CERTIFICATE OF APPROPRIATENESS

RE: Application Number 20-6736; 1504 Longfellow Street, Boston – Edison Historic District

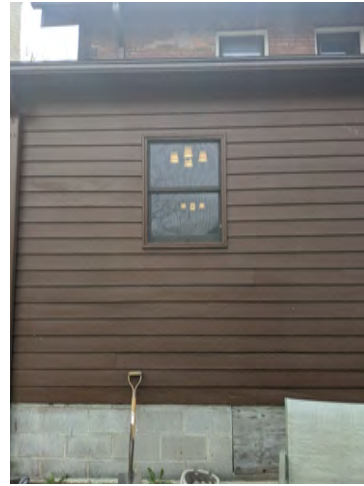
This COA has been issued with the following conditions:

- The replacement windows are to be wood, or aluminum-clad wood rather than vinyl-clad wood.
- The light configuration is to be 1/1 without muntins in either sash.
- The applicant shall revise the submission to reflect the updated replacement window product and light configuration and submit to HDC staff for review and approval prior to pulling the building permit for the project.

Window to be replaced:

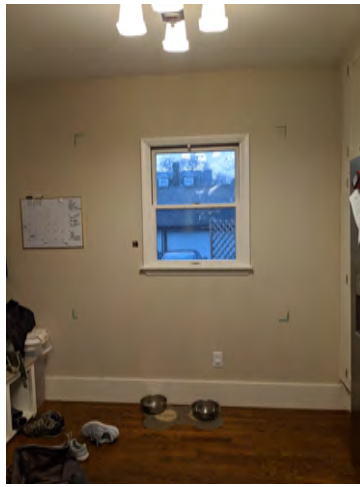
- The replacement windows are to be wood, or aluminum-clad wood rather than vinyl-clad wood.
- The light configuration is to be 1/1 without muntins in either sash.
- The applicant shall revise the submission to reflect the updated replacement window product and light configuration and submit to HDC staff for review and approval prior to pulling the building permit for the project.

Diagram not drawn to scale and colors not accurate. Trim will match current house color:

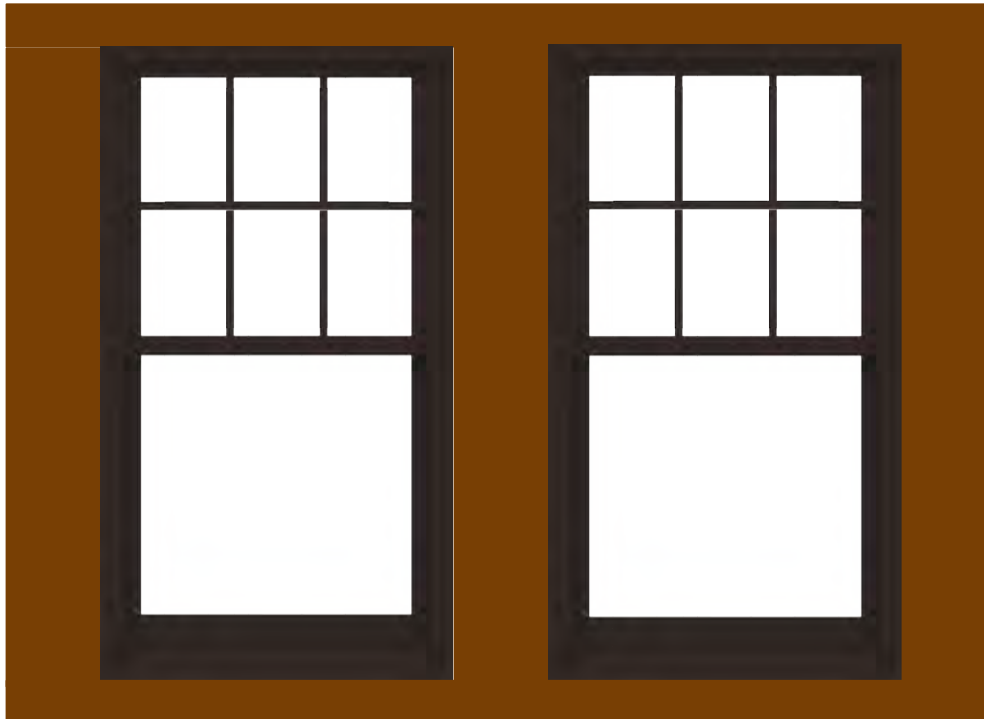
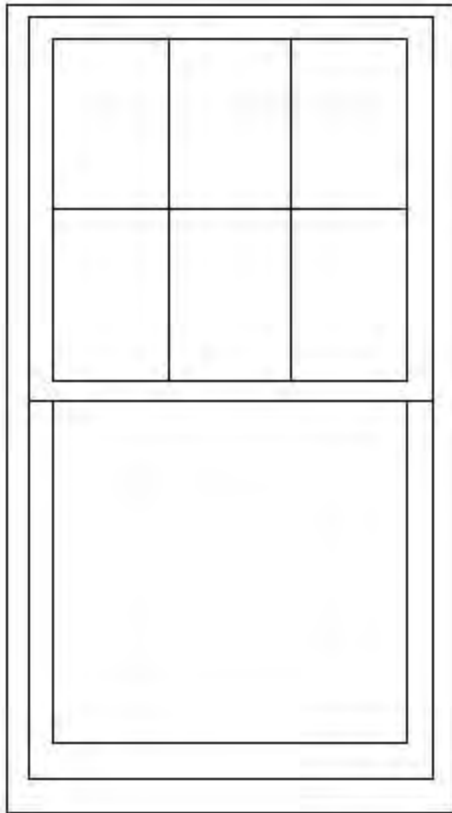
- The replacement windows are to be wood, or aluminum-clad wood rather than vinyl-clad wood.
- The light configuration is to be 1/1 without muntins in either sash.
- The applicant shall revise the submission to reflect the updated replacement window product and light configuration and submit to HDC staff for review and approval prior to pulling the building permit for the project.
